MODIFICATION REQUEST:

14-18 Boondah Road, Warriewood

***MP10_0177 MOD 7 - Modifications to Allow
Staged Strata Subdivision***

Director-General's
Environmental Assessment Report
Section 75W of the
Environmental Planning and Assessment Act 1979

Figure 2: Site Plan demonstrating the layout of the residential and community facility (pool) buildings of Stage 1 on the subject site.

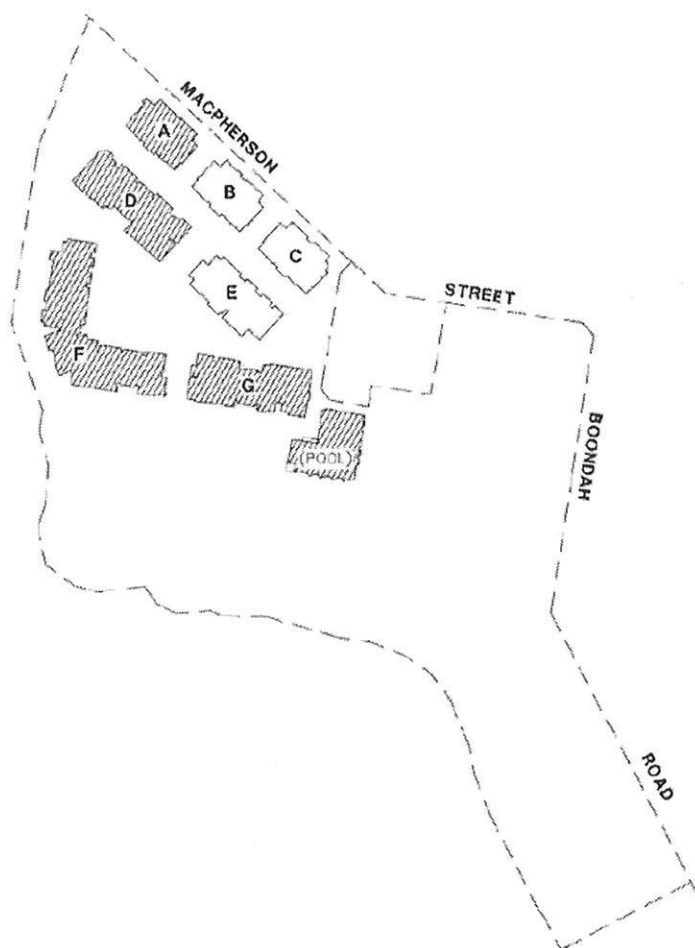
As demonstrated in **Figure 2**, the strata subdivision of these buildings will be carried out in stages with an initial strata plan being registered for Buildings B, C and E. Future strata plans of subdivision will be registered for all or some of the remaining approved buildings, being Buildings A, D, F, G and the pool building in an order to be determined by the proponent.

As demonstrated in **Figure 2**, the proposed strata subdivision will be carried out in stages with an initial strata plan being registered for Buildings B, C and E. Future strata plans of subdivision will be registered for all or some of the remaining approved buildings, being Buildings A, D, F, G and the pool building in an order to be determined by the proponent.

Figure 3: Proposed Torrens Title Subdivision of the subject site (subdivision application currently being assessed by Council N0383/11).

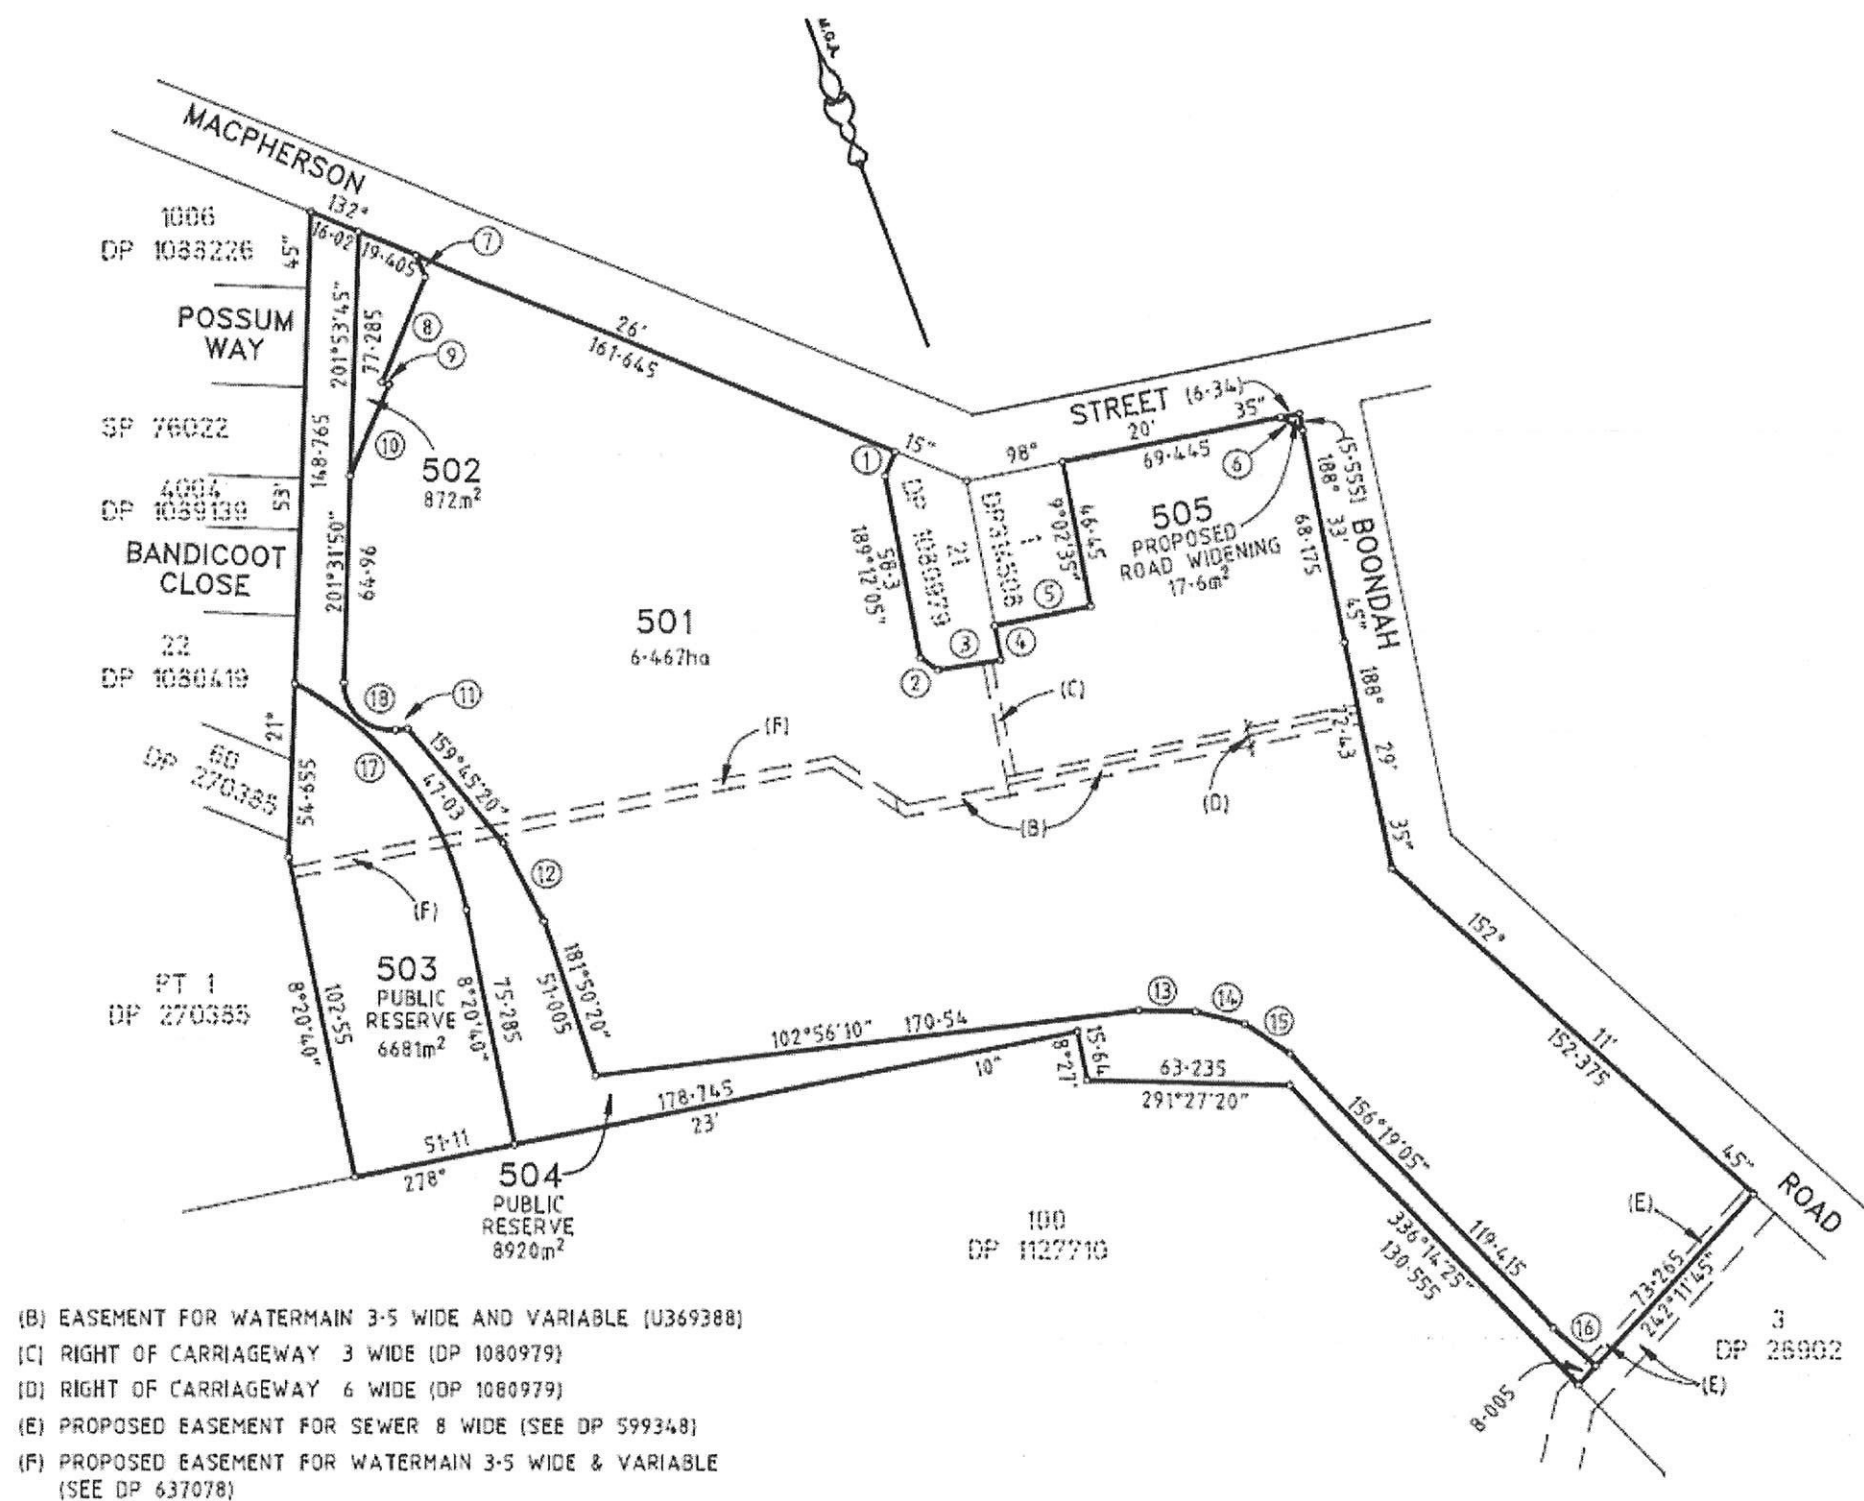
Council is currently assessing Integrated Development Application No. N0383/11 for Torrens Title subdivision of the subject site. **Figure 3** above demonstrates the proposed plan of subdivision.

The strata plans submitted with the subject application demonstrate covenants for an easement for the watermain, rights of carriageway and an easement for sewer which satisfy the requirements of Condition A6(2). It is noted that Council does not object to these covenants.
